Access Compliance Report

Public Rights-of-Way (Curb Ramps)

Intersection ID: 3840	Main Street: CHIMNEY RIDGE TL	Cross Street: DEER CROSS TL	Location: NE
ADA ID: 8BF815323E77	Ramp Type: Directional1	Initial Pass/Fail: Fail	Overall Compliance: No
Severity Score: 8.75			
Codes/Mitigation Info/Possible Solution		Field Measurements/Component Compliance

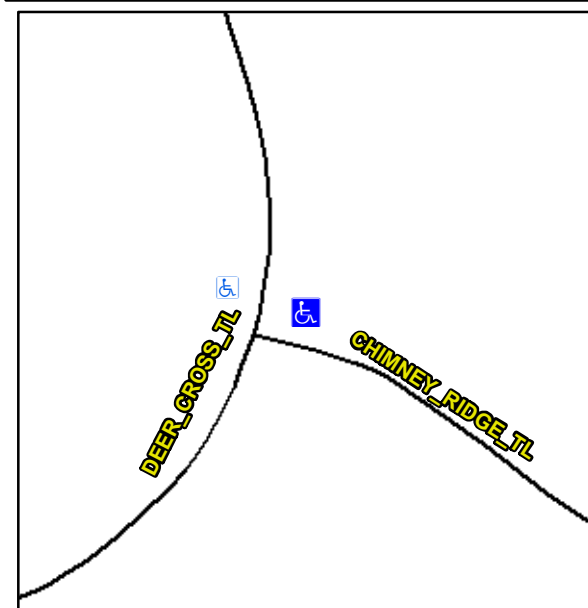
R304.5.1

Compliance	Description	Data	Compliance	Description	Data
N/A	Ramp Length (in)	30.0	N/A	Grade Break?	N/A
No	Ramp Width (in)	36.0	N/A	Grade Break Slope (%)	0.0
Yes	Ramp Slope (%)	6.6	N/A	Grade Break XSlope (%)	0.0
Yes	Ramp XSlope (%)	1.7			
N/A	Flare Type LT	N/A	N/A	Flare Type RT	N/A
N/A	Flare Slope LT (%)	N/A	N/A	Flare Slope RT (%)	0.0
N/A	Flare Traversable LT?	N/A	N/A	Flare Traversable RT?	N/A
N/A	Landing Length (in)	0.0	N/A	DWS Provided?	N/A
N/A	Landing Width (in)	0.0	N/A	DWS Contrast?	N/A
N/A	Landing Slope (%)	0.0	N/A	DWS Length (in)	N/A
N/A	Landing X Slope (%)	0.0	N/A	DWS Full Width?	N/A
N/A	Landing Curb? (Y/N)	N/A	N/A	DWS Offset LT (in)	N/A
N/A	Shared Landing?	N/A	N/A	DWS Offset RT (in)	N/A
N/A	Gutter Ponding?	0.0	N/A	Gutter Slope (%)	N/A
N/A	Gutter Lip Ht (in)	0.0	N/A	Gutter X Slope (%)	N/A
N/A	Painted X Walk1?	No		Road Slope (%)	1.8
	X Walk 1 Direction	To W		Road X Slope (%)	5.1
	X Walk 1 Width (in)	N/A		Clear Space?	N/A

Remove & Replace Entire Ramp.
